REMARKS

Claims 25-41 are pending the application.

Fig. 2

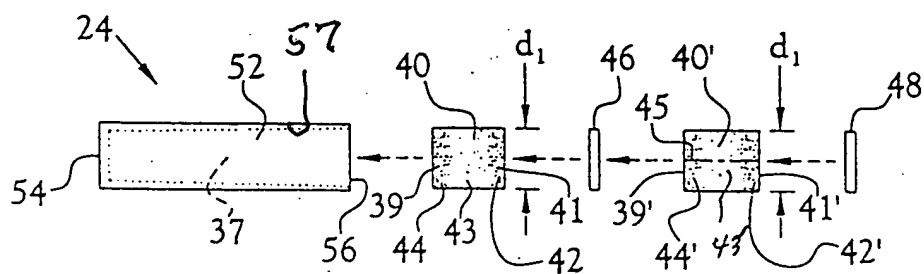
The drawings are objected to due to the absence of numerals 57, 59 and 49 from Figure 2. At page 11, the numerals "59" and "49" have been changed to "37" and "43," respectively. A Replacement Sheet which includes the missing numeral 57 from Figure 2 is submitted herewith. Also, a "proof" sheet of drawings, containing Figure 2 is included and on which the added numeral 57 is indicated in red for the Examiner's approval. Upon such approval, entry of the Replacement Sheet into the present application is requested.
